Project	IEEE 802.16 Broadband Wireless Access Working Group < http://ieee802.org/16 >
Title	SDMA support in AAS mode for OFDMA PHY
Date Submitted	2005-01-10
Source(s)	Ran Yaniv, Tal Kaitz, Danny Stopler, Naftali Chayat, ran.yaniv@alvarion.com Vladimir Yanover Alvarion Ltd.
Re:	IEEE P802.16e/D5a BRC
Abstract	
Purpose	
Notice	This document has been prepared to assist IEEE 802.16. It is offered as a basis for discussion and is not binding on the contributing individual(s) or organization(s). The material in this document is subject to change in form and content after further study. The contributor(s) reserve(s) the right to add, amend or withdraw material contained herein.
Release	The contributor grants a free, irrevocable license to the IEEE to incorporate material contained in this contribution, and any modifications thereof, in the creation of an IEEE Standards publication; to copyright in the IEEE's name any IEEE Standards publication even though it may include portions of this contribution; and at the IEEE's sole discretion to permit others to reproduce in whole or in part the resulting IEEE Standards publication. The contributor also acknowledges and accepts that this contributi

Figure XXX – Pilot patterns for AAS mode in AMC zone. Symbol offset is relative to the beginning of the zone. Pilot polarity for each pattern is given in brackets.

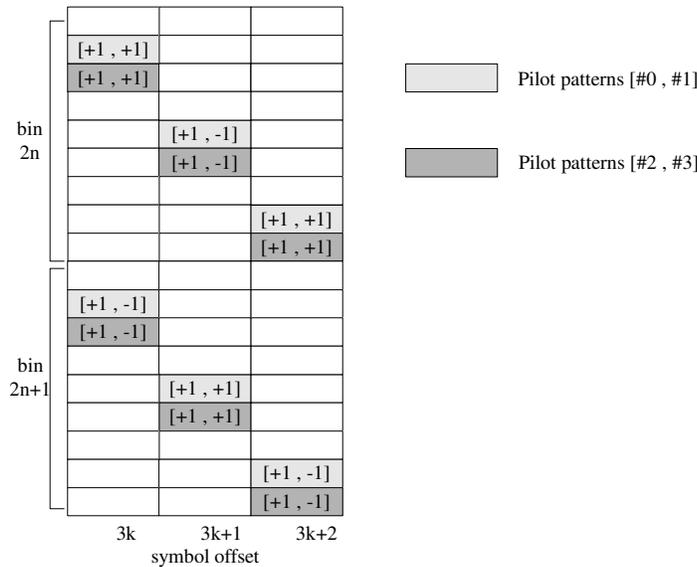
8.4.6.3.2 AMC support for SDMA

The pilots in an AMC AAS zone are regarded as part of the allocation, and as such shall be beamformed in a way that is consistent with the transmission of the allocation’s data subcarriers. In an SDMA region, the pilots of each allocation may correspond to a different pilot pattern. A pilot pattern consists of location and polarity. The pilot patterns are depicted in figure XXX. Data subcarriers shall be punctured to obtain patterns #2 and #3. Subcarriers shall only be punctured if there is an allocation associated with the corresponding pattern, as described in the AAS SDMA DL IE(). Data subcarriers shall be punctured after constellation mapping in the case of CC encoding, and prior to constellation mapping in the case of CTC encoding. In the latter case, the FEC block shall be truncated to accommodate the punctured subchannel structure, and the data subcarrier enumeration of Eq. (116) shall not be applied. Instead, data subcarriers within a slot shall be enumerated starting from the first OFDMA symbol at the data subcarrier that is lowest in frequency, continuing in ascending frequency order throughout the slot’s subcarriers in the same symbol, then going to the next symbol at the subcarrier lowest in frequency, and so on.
